IMPERIAL COMMUNITY COLLEGE DISTRICT
IMPERIAL VALLEY COLLEGE
WATER AND WASTEWATER PLANT IMPROVEMENTS

ADDENDUM #03

THE FOLLOWING ITEMS ARE LISTED AS CORRECTIONS OR CLARIFICATIONS TO THE CONSTRUCTION DOCUMENTS.

50k GALLON WASTEWATER PLANT - ENLARGED PLAN

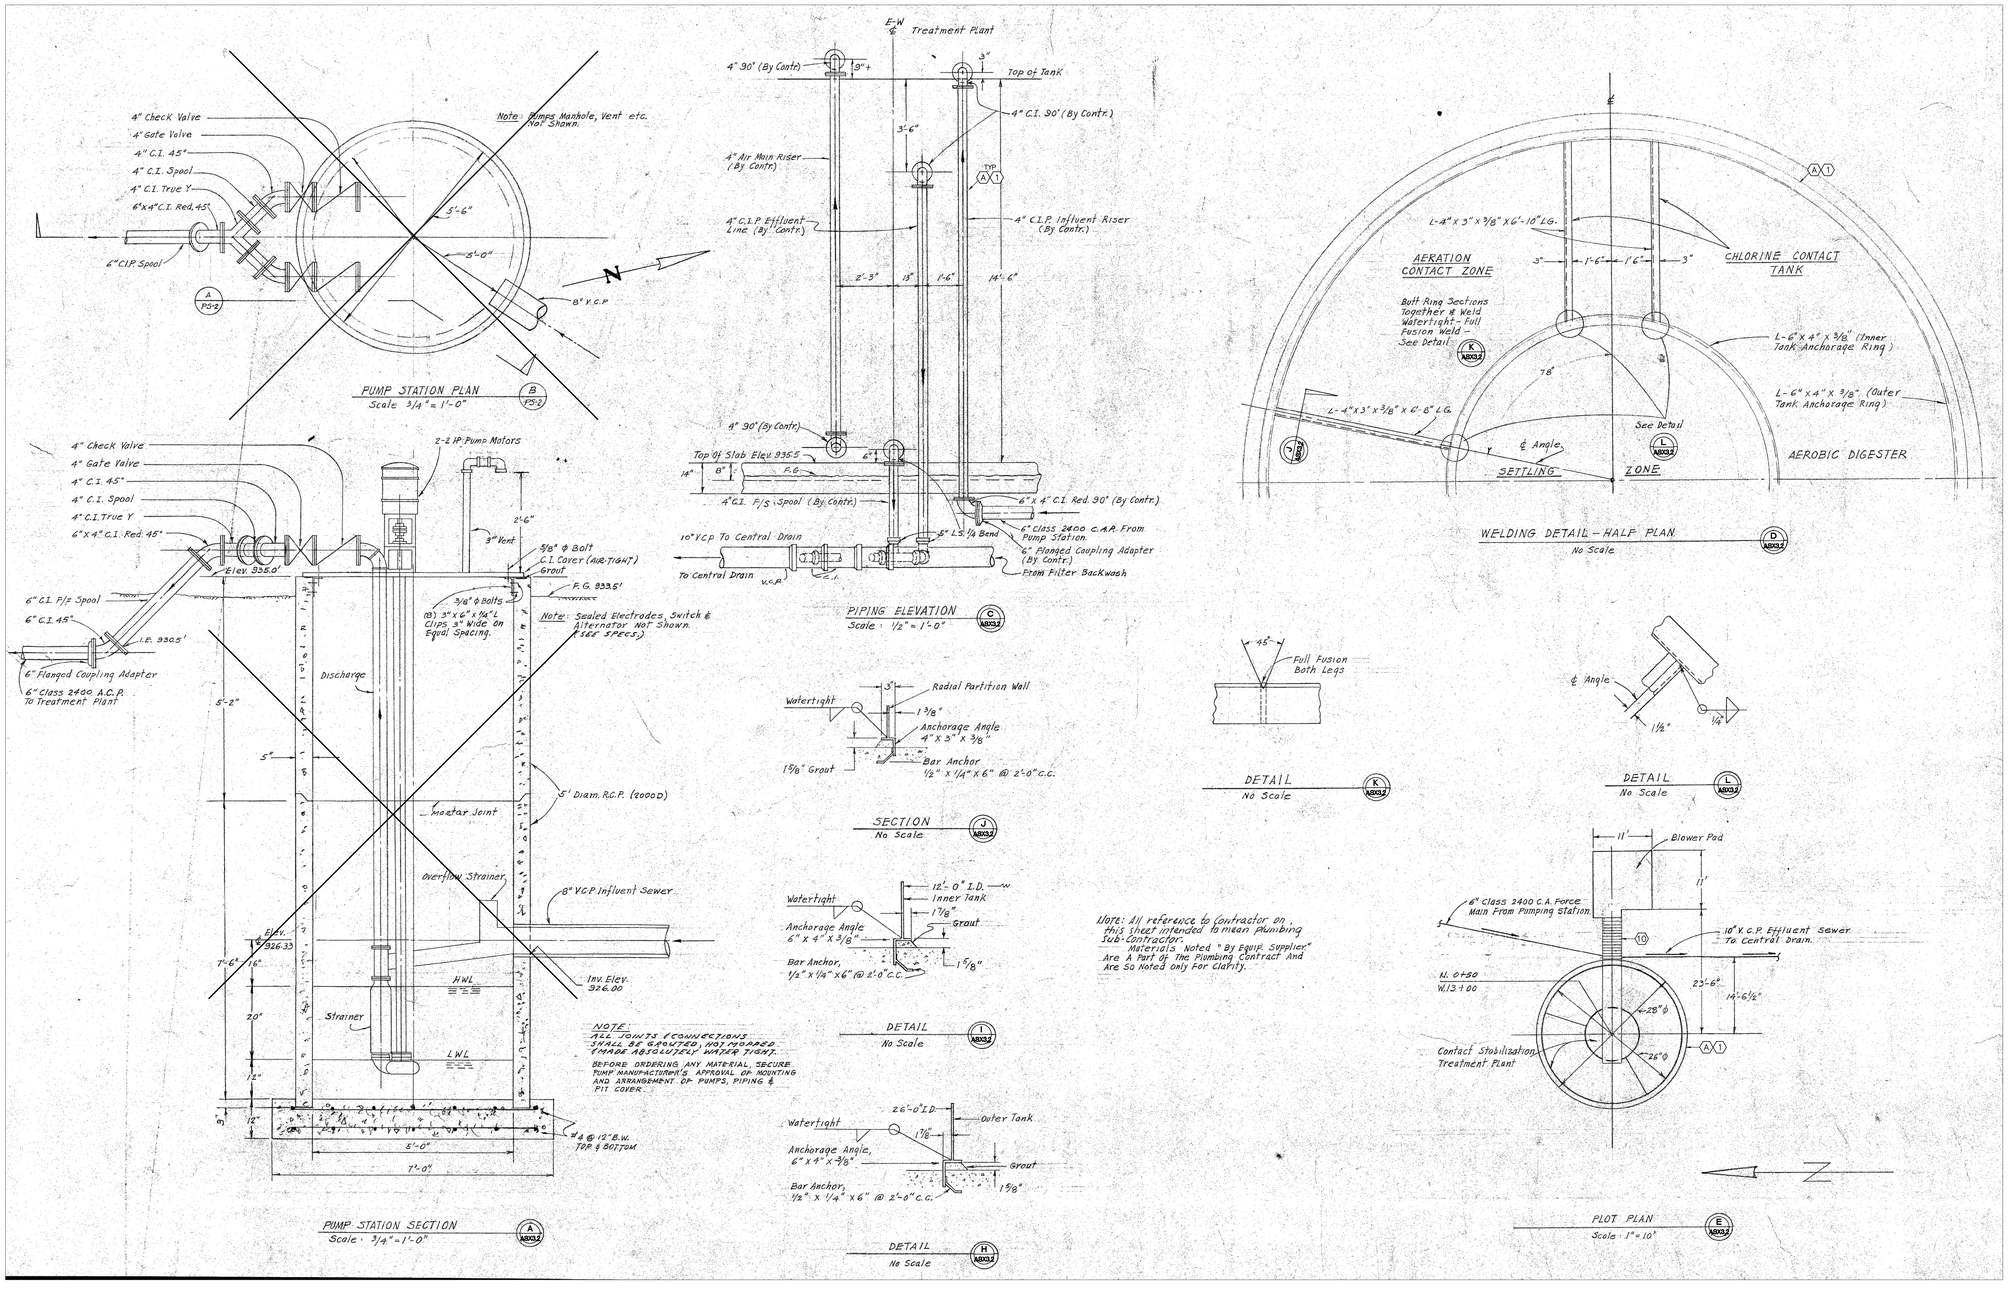
5. ASX3.2 – 50K GALLON WASTEWATER PLANT – ENLARGED PLAN
    a. Sheet ASX3.2 was omitted from Bid Set in error, Sheet ASX3.2 shall be included in Bid Set Drawings and is attached to this addendum.

(1) PROVIDE SHERWIN WILLIAMS DURA-PLATE 6100 HIGH PERFORMANCE EPOXY W/ HIGH BUILD HARDENER B62VHB475. APPLY DRY FILM THICKNESS OF 275 MILS PER MANUF REQUIREMENTS TO 50K AND 100K GALLON PACKAGED WASTEWATER PLANT FOR INTERIOR AND EXTERIOR SURFACE AND ASSOCIATED COMPONENTS
